March 15, 2011

Subject: 2010 Rulemaking Proceeding Phase II on Appliance Efficiency Regulations
(Docket # 09-AAER-2)

Recently the California Energy Commission (CEC) held a second workshop on the topic of energy efficiency requirements for Battery Charging Systems. The CEC presented a draft Staff Report on the Staff's analysis of proposed energy efficiency requirements for these products. As a manufacturer of specialized and sophisticated non-consumer Battery Charging Systems, Motorola Solutions, Inc. (MSI) was pleased to attend the workshop and appreciates the opportunity to comment on the draft Staff Report. As small, non-consumer Battery Charging Systems are complex and vary greatly in functions and features, we understand that appropriate and effective regulation is a complex topic, and we look forward to a continuing dialogue regarding energy efficiency for Battery Charging Systems. In this letter, we offer comments on the current draft Staff Report.

Figure B3: Switch mode waveforms with improved power factor

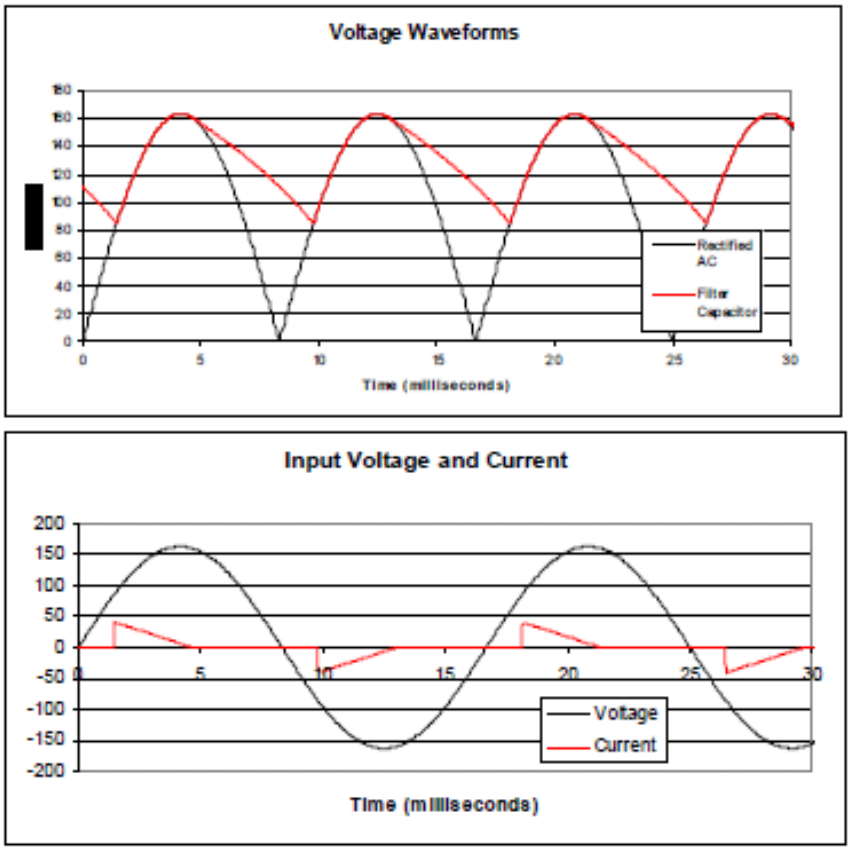
Motorola Solutions, Inc. has substantially confirmed the results[1] in Figures B3 and B4, assuming ideal rectifiers and an extremely low power supply Under Voltage Lock Out (UVLO) of 20 volts. A graph of some of Motorola Solutions, Inc.'s results is shown below. Appended to this graph are curves showing the lowest capacitor voltage reached throughout the AC power line cycle for each value of capacitance considered. An example of such variation in capacitor voltage can be seen in the top graph of Figure B3 above.

Figure B4: Optimum Filter Capacitor Selection

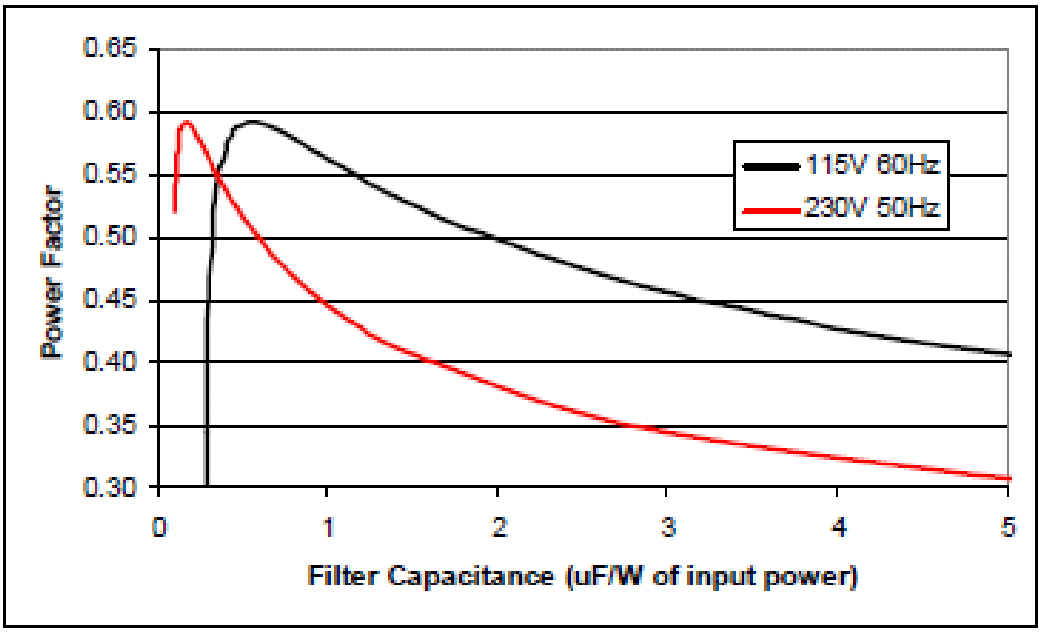
Note that Motorola Solutions, Inc. is unable to replicate the Figure 4B CASE report's 115V Power Factor values on the left end of the curve that go down to .3. This is because Motorola Solutions, Inc.'s calculations show that the power supply collapses (the capacitor voltage reaches the UVLO level) for a PF much below .48. Indeed, they are very close to zero at PF = .48.

Figure 2 Schematic from the Reference Design Report (RDR-142) by Power Integrations

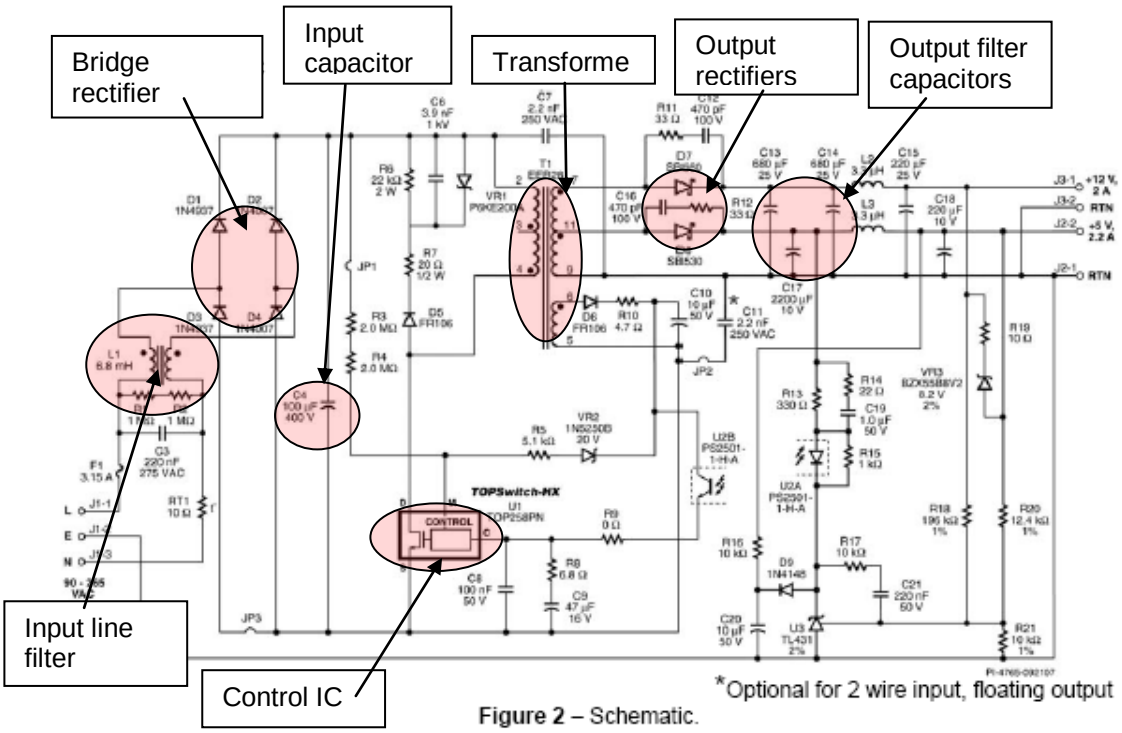
We analyzed the Power Integrations Reference Design Report RDR-142 and determined that it had a Power Factor less than .55 when powered from a line voltage source of 115vac. The power converter used in this design has a control IC that switches the input (primary) inductor of the transformer for the purpose of sourcing power to a load. The transformer scales the output (secondary) inductor current to the required current peak as needed to support a load. The transformer core and wire are sized so that the transformer runs at optimal efficiency without the possibility of magnetic saturation.

We used the power supply design software by Power Integrations to investigate design changes required to meet a power factor of .55. The results of this analysis were compared to the analysis performed by Power Integrations in their Reference Design Report (RDR-142). We determined from this analysis which parts needed to be changed. See the highlighted schematic below.

In the redesign analysis, the input capacitance was reduced from 100uF to try to meet the requirement of 0.55uF/Watt. Considering the input power of 44W, the resulting input capacitance is 24uF. (44Watt x 0.55uF/Watt = 24uF)

Reducing the input capacitance to 24uF causes the minimum DC bus voltage to drop well below the minimum required voltage of 70V for control IC operation when the nominal 100VAC line voltage of Japan falls to its minimum of 90VAC. The power converter needed to be redesigned. See the results below.
